Mandatory Product Update/Safety Bulletin

PCU15-013

PC3/Titan Overspeed Safety Device

SUB COMPONENT
Overspeed Safety Device - Flywheel Assembly

Flywheel Assembly

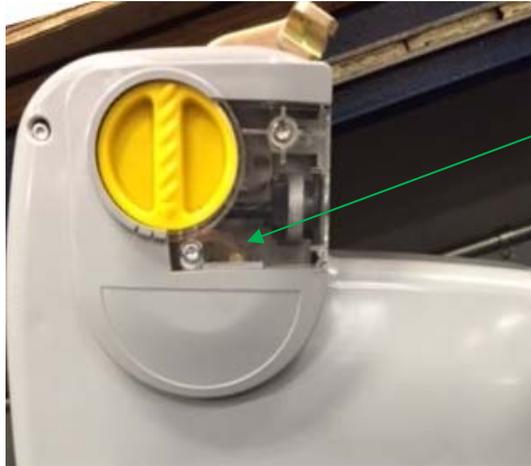
1. As outlined in the Power Climber Operators Manual, while powering the hoist "UP" and "Down" approximately 3 feet, look through the window near the Overspeed Brake Test Button to view that the flywheel is rotating. **If the flywheel is not rotating or stops rotating during operation, hoist must be removed from service immediately.**

2. If Flywheel Assembly passes inspection, the hoist may be used for up to 120 days as long as the Daily Test Requirements are performed as outlined in Power Climber Operators Manual.
3. If the Flywheel Assembly does not pass inspection, hoist must be removed from service until update has been applied.

1. A Flywheel Assembly update must be applied, please contact Service@PowerClimber.be or +32 3 451 05 00
